# Site Accessibility Evaluation

## Americans with Disabilities Act Title II (Public Services: State and Local Government)

### **DOT Operations Center**

**3275 Akers Dr  
Colorado Springs, CO  
80922**

### Finding: 1

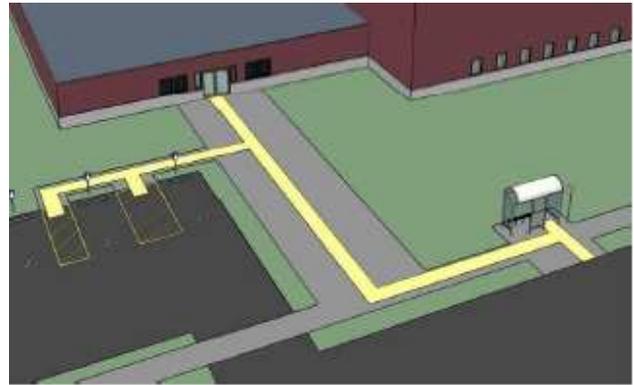
The accessible parking is not located on an accessible route of travel to the accessible building entrance.

Pedestrian ramp does not align w/aisle

Submit w/o for correction. Area needs to be re-striped and access aisle to sidewalk path of travel needs to align w/accessible ramp.

Corrective Action: Parking area was repaved to meet seamless transition from access aisle to access route. Corrected 18 Oct 2016.

### Finding: 2

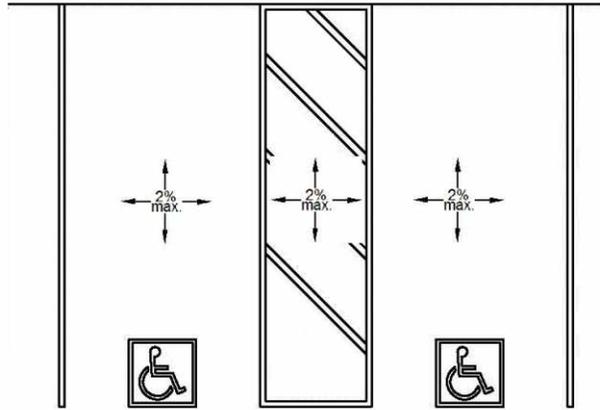
The running slope of the access aisle (long dimension) exceeds 2%.

Running slope ranges  
from 1% and 9.5%

Re-pave access aisle and ensure a 2% maximum cross and running slope for the full length and width of the access aisle.

### Finding: 3

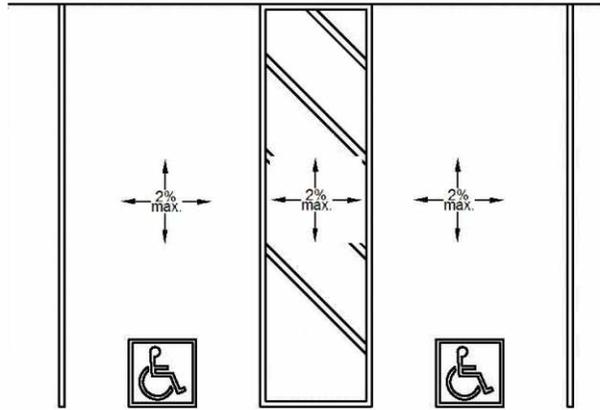
The running slope (long dimension) of the accessible parking stall exceeds 2%.

Running slope ranges  
from 1% up to 9.5%

Re-pave designated ADA parking stalls and ensure a 2% maximum cross and running slope for the full length and width of the parking stalls.

### Finding: 4

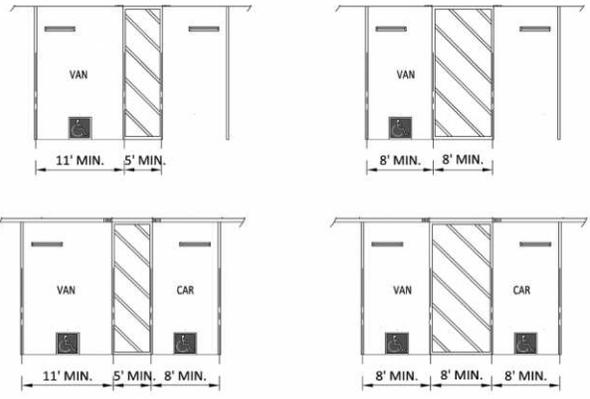
The accessible parking stall is not wide enough.

Van parking stall  
measures 9.8 feet in  
width

Re-stripe ADA parking stall/s and access aisle/s. ADA parking stalls shall measure 8 ft minimum in width measured to the centerline of the paint stripes. Access aisles shall measure 5 ft minimum in width measured to the centerline of the paint stripes. Ensure ADA van parking stall/s are 8 feet wide minimum with an access aisle of 8 feet wide minimum or 11 feet wide minimum with an access aisle of 5 feet wide minimum measured to the centerline of the paint stripes.

### Finding: 5

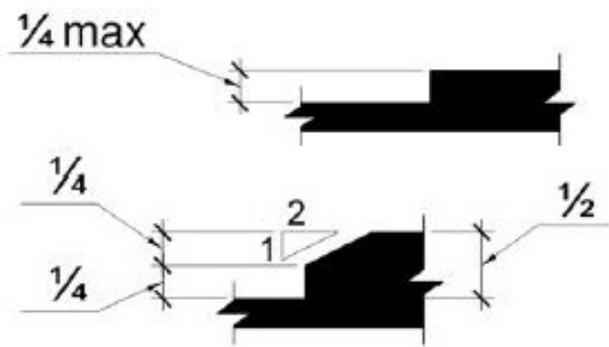
The walkway contains abrupt vertical edges and/or variations over a 1/4 inch.

3/4 of an inches upheaval.

Submit a work order to have sidewalk area shaved.

### Finding: 8

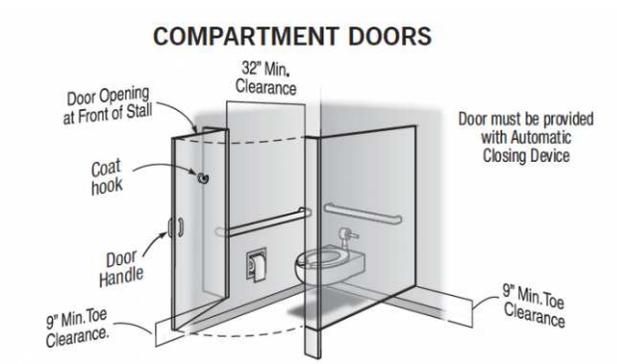
The compartment door is not self closing.

Compartment door not self closing

Adjust or install automatic closing hinges.

Corrective Action: W/O 381195 submitted.

### Finding: 9

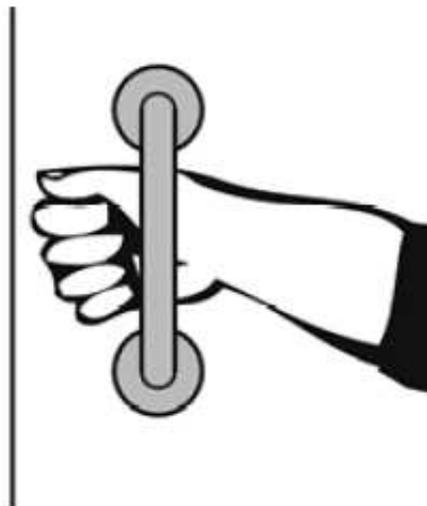
The water closet compartment door is missing a loop handle on the inside.

Missing inside loop handle on compartment door

Install loop or U-shaped handle on inside of compartment door.

Corrective Action: W/O 381194 submitted. Installed loop handles on inside/outside of stall door-completed 3/10/2017.

### Finding: 10

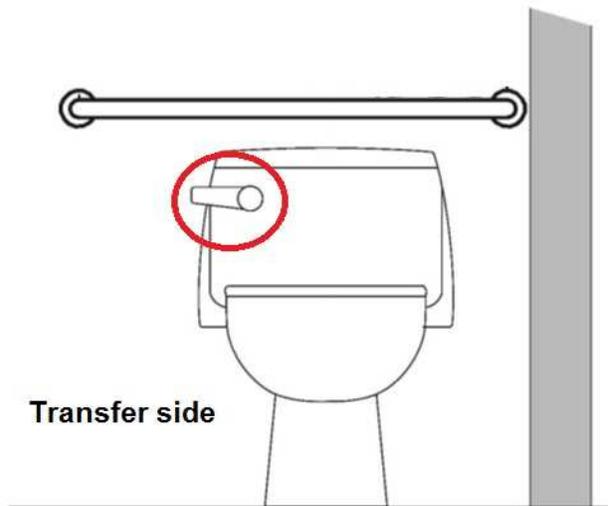
The flush handle is located on the wrong side of the toilet.

Flush handle located  
on closed side

Relocate flush handle to opposite side (open side of toilet area).

Corrective Action: W/O 381193 submitted. Installed new sensor type flush valve 3/14/2017.

### Finding: 13

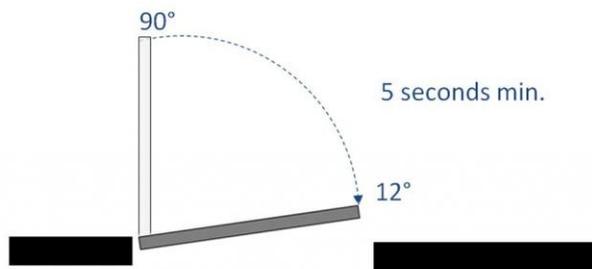
The door is equipped with a door closer and returns to a closed position too quickly.

Door from hallway to vestibule closed in 1.38 seconds and door from vestibule to restroom closed in 2.14 seconds.

Adjust both door closers to allow a minimum of 5 seconds to move from the open position at 90 degrees to 12 degrees from the latch/locking mechanism.

### Finding: 14

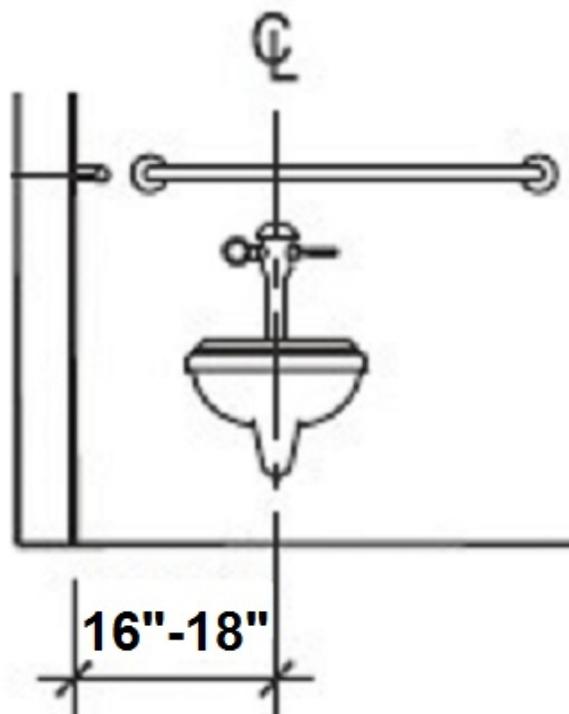
The toilet is not located within the range allowed from the side wall or partition.

18.5 inches from side wall

Re-position toilet between 16 inches minimum and 18 inches maximum from centerline of toilet to side wall. May require plumbing alteration.

### Finding: 15

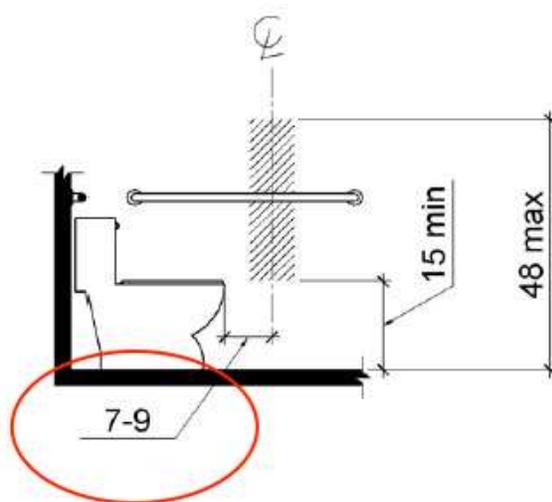
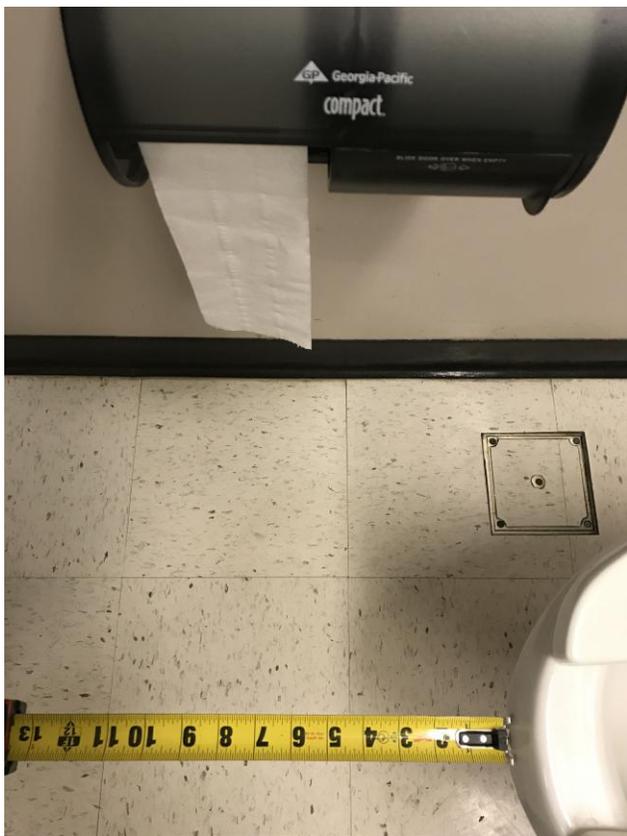
The toilet paper is not installed within the compliant range.

5 inches in front of toilet

Re-position toilet paper dispenser to be within 7 inches minimum to 9 inches maximum in front of the toilet measured to the centerline of the dispenser.

### Finding: 16

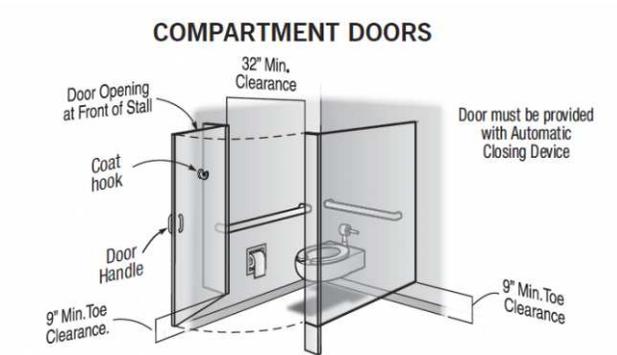
The compartment door is not self closing.

Compartment door not self closing

Corrective Action: W/O 381190 submitted.
